Thor Motor Coach Recall Repair Instructions

Recall # 17V-362

Description/Title: **2017 Challenger 37YT Generator Exhaust Pipe**

Service Campaign # : **RC000138**

Figure 1

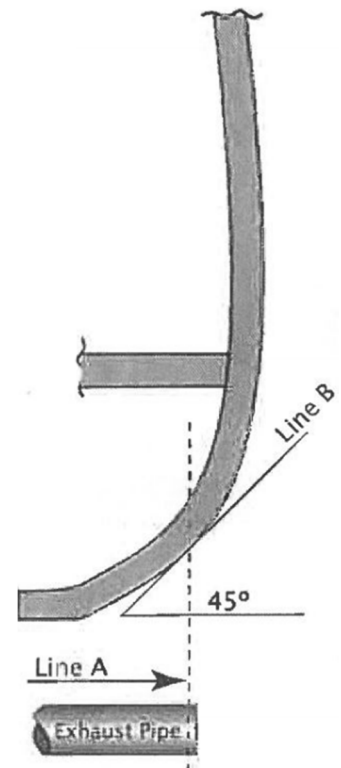
Issue: On certain 2017 Challenger 37YT motorhomes the generator exhaust pipe may be improperly located or missing.

Verify the generator exhaust pipe is present and conforms to the standards shown in figure 1. If so, no further action is required.

If the generator exhaust pipe is present, but not properly located, loosen the exhaust pipe hanger(s) and adjust the position of the exhaust pipe for proper clearance as illustrated in Figure 1.
